PRAIRIE VILLA AT BEACON HILL

RE: SUB 2004-11 -- One-Step Final Plat of Prairie Villa at Beacon Hill Addition

CASE NUMBER: SUB 2004-11 -- PRAIRIE VILLA AT BEACON HILL ADDITION

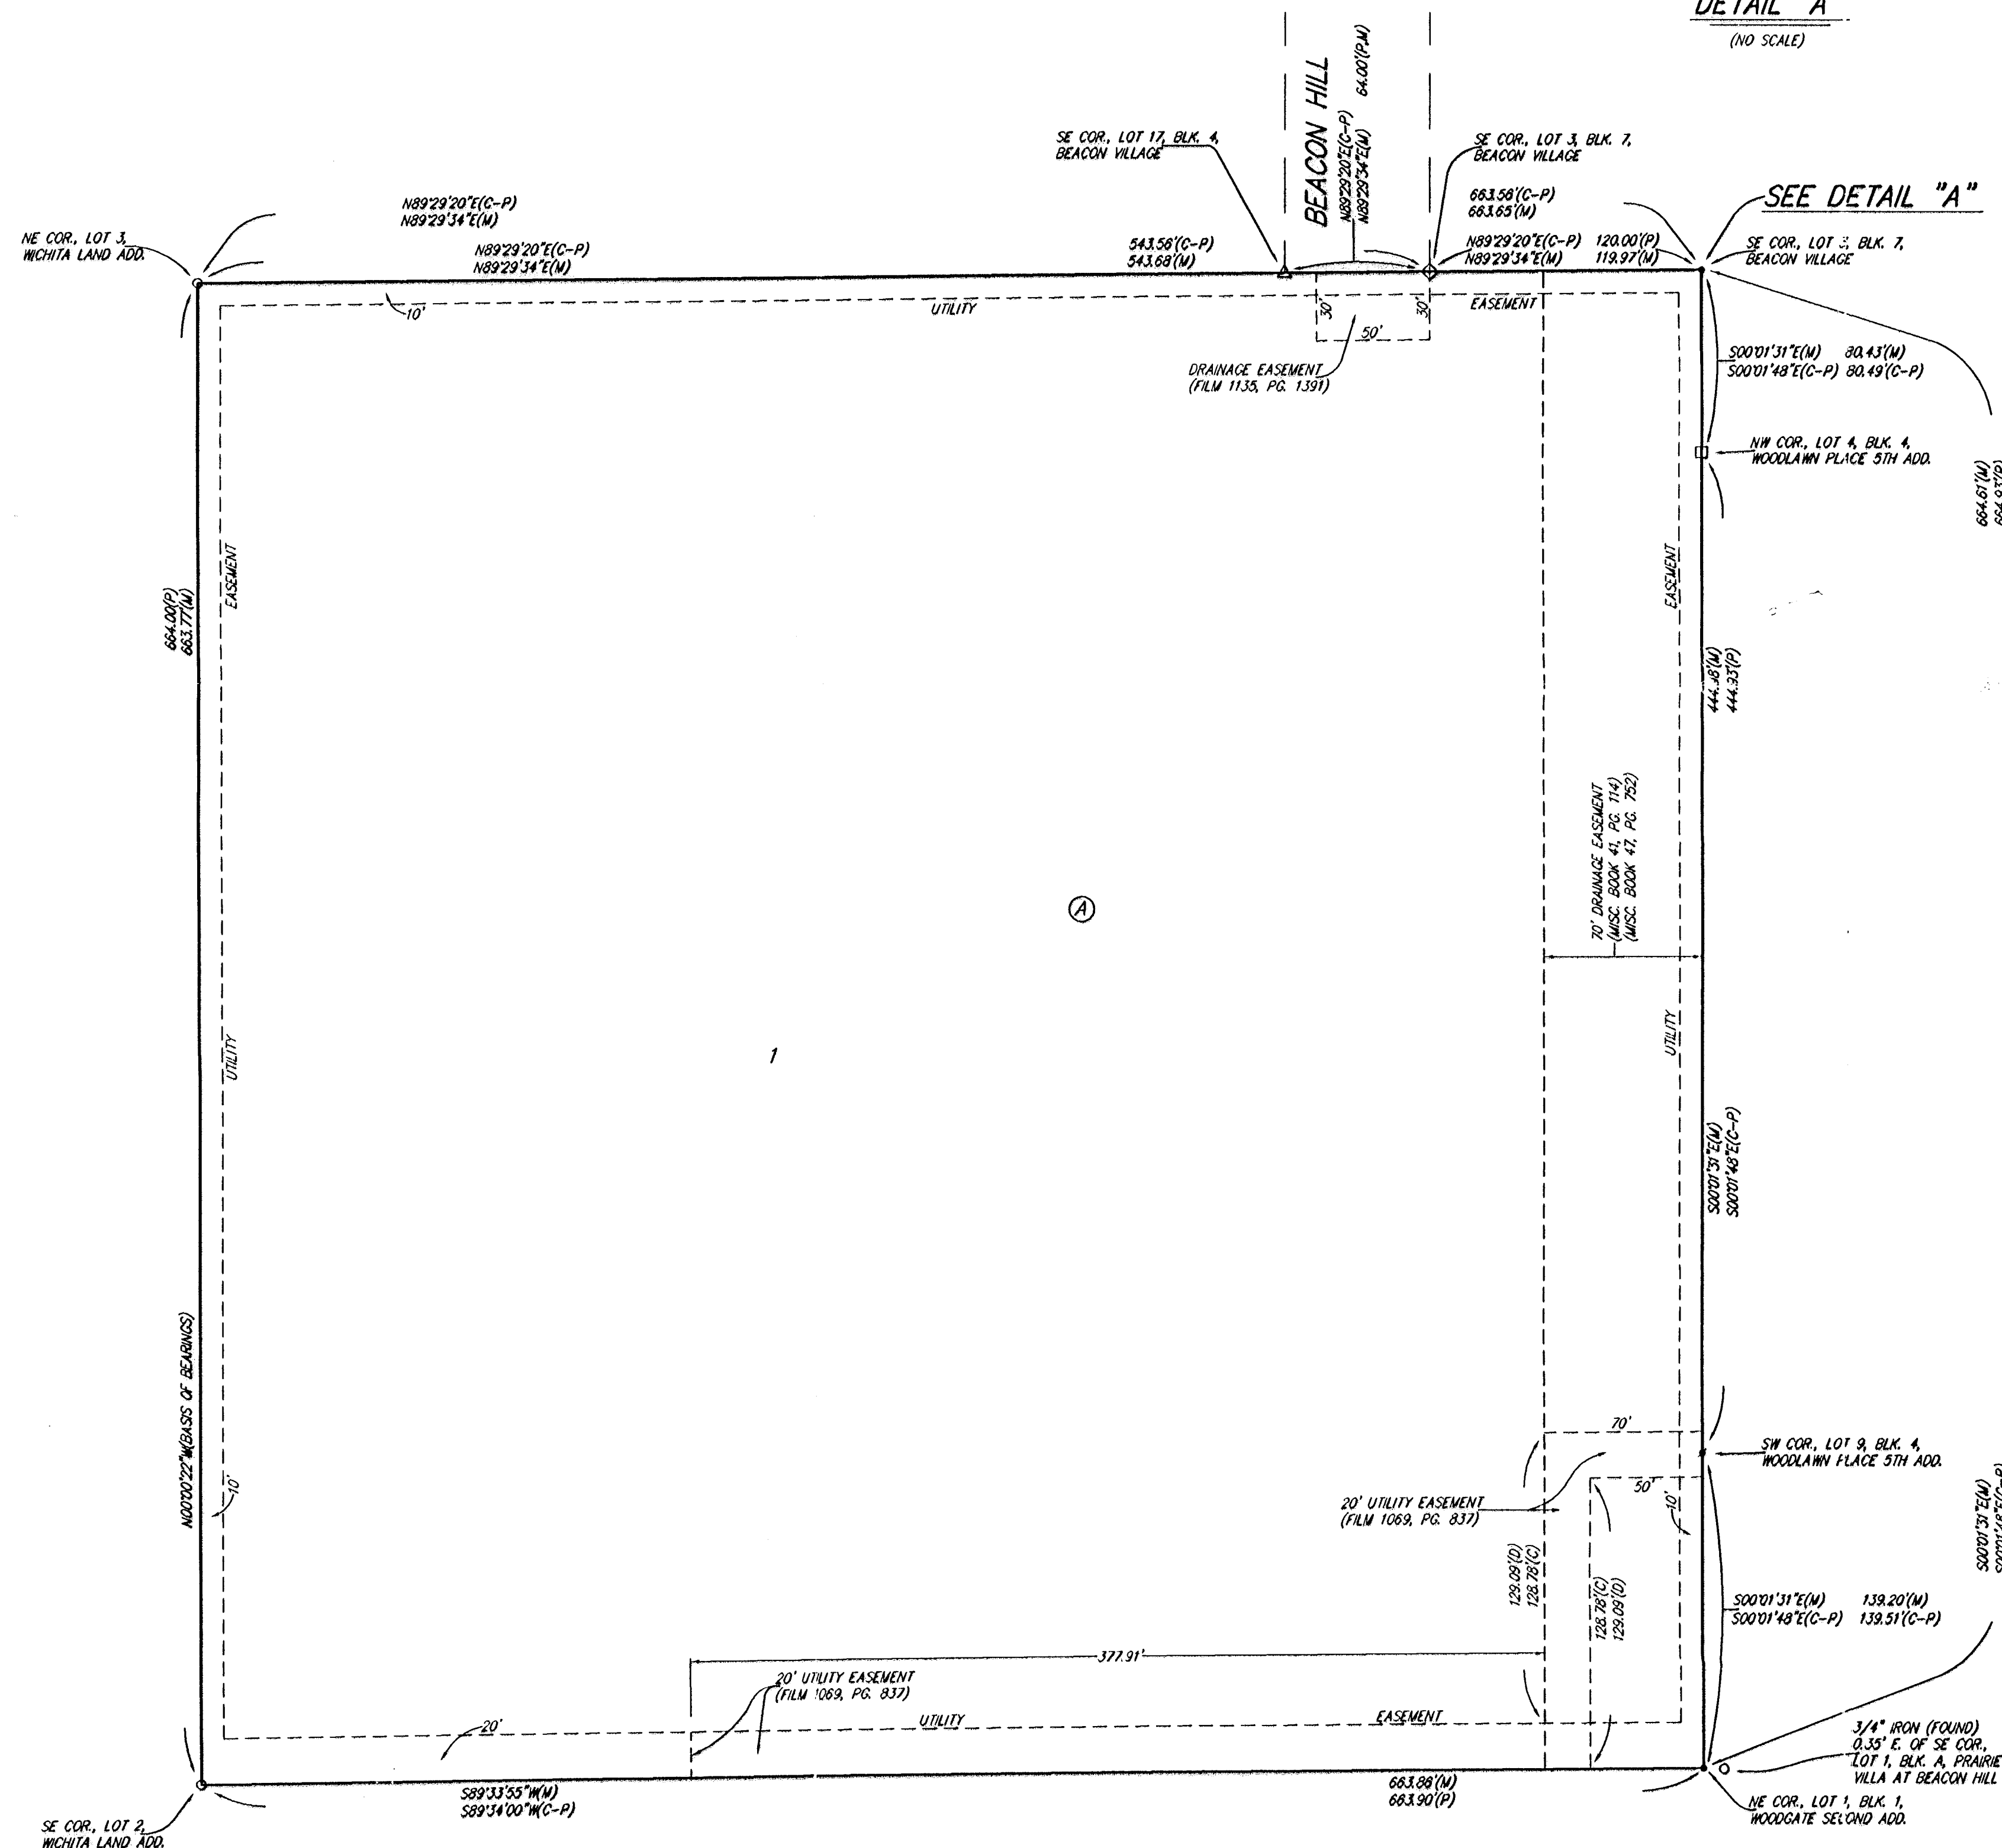
- A. Sanitary sewer is available to serve the site. The applicant shall guarantee the extension of City water to serve the lots being platted.
- B. If improvements are guaranteed by petition, a notarized certificate listing the petitions shall be submitted to the Planning Department for recording.

- C. City Engineering needs to comment on the status of the applicant's drainage plan. City Engineering has requested a drainage easement.
- D. City Fire Department needs to comment on the need for a turnaround. In lieu of a public right-of-way turnaround, a private drive circulation system is required with a 20-ft paved surface, 35-ft radius turnarounds or as approved by City Fire Department; and a 29-ft roadway at the entrance.

- F. The platator's text shall include language that a drainage plan has been developed for the plat and that all drainage easements, rights-of-way, or reserves shall remain at established grades or as modified with the approval of the applicable City or County Engineer, and unobstructed to allow for the conveyance of stormwater.

- G. The applicant shall install or guarantee the installation of all utilities and facilities which are applicable and described in Article 8 of the MAPC Subdivision Regulations. (Water service and fire hydrants required by Article 8 for fire protection shall be as per the direction and approval of the Chief of the Fire Department.)

NOTE:
A DRAINAGE PLAN HAS BEEN DEVELOPED FOR THIS SUBDIVISION AND IS ON FILE WITH THE CITY OF WICHITA, KANSAS. DRAINAGE INTENT SHALL REMAIN AS DEPICTED OR AS MODIFIED WITH THE APPROVAL OF THE CITY ENGINEER OF THE CITY OF WICHITA, KANSAS. NO OBSTRUCTIONS WHICH IMPEDE THE FLOW OF THIS DRAINAGE PLAN SHALL BE ALLOWED.
